Errata Sheet

V 1.3, 2004-09

Device	**C504-2E**
Marking/Step	**Step CB**
Package	**P-MQFP-44**

This Errata Sheet describes the deviations from the current user documentation.

Figure 1 Reset Circuitries

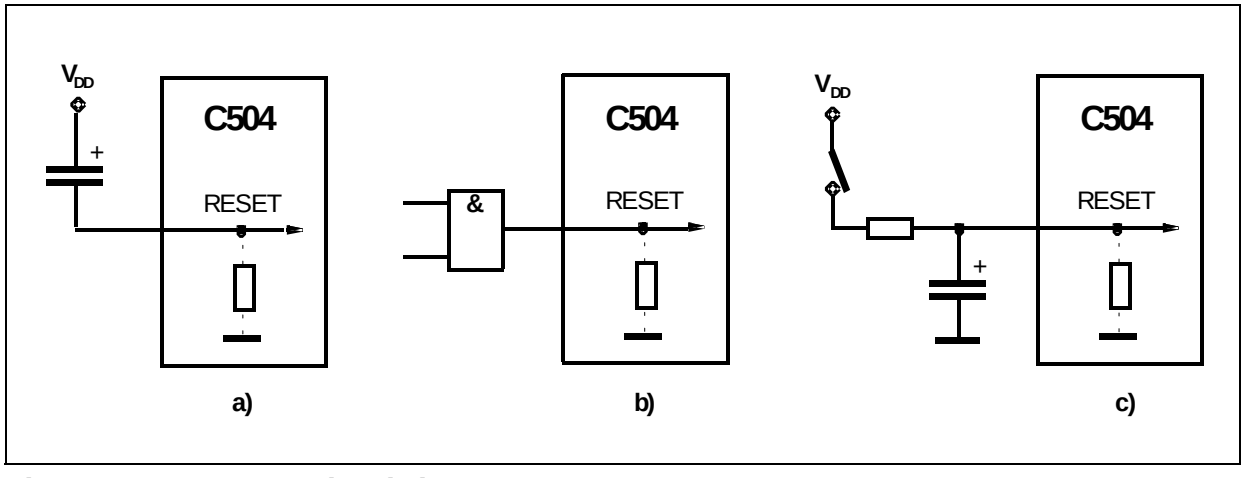
RST.1: Figure in User’s Manual and Data Sheet regarding the Reset Circuitries is incorrect

Figure 5-1 in User’s Manual and Figure 6 in Data Sheet show incorrectly that the RESET pin has an internal pullup resistor connected to the V_{DD}. Instead, at the RESET pin, an internal pulldown resistor is connected to the V_{SS}. The correct implementation is illustrated in **Figure 1**.

This correction will be updated to the future versions of the User’s Manual and Data Sheet.
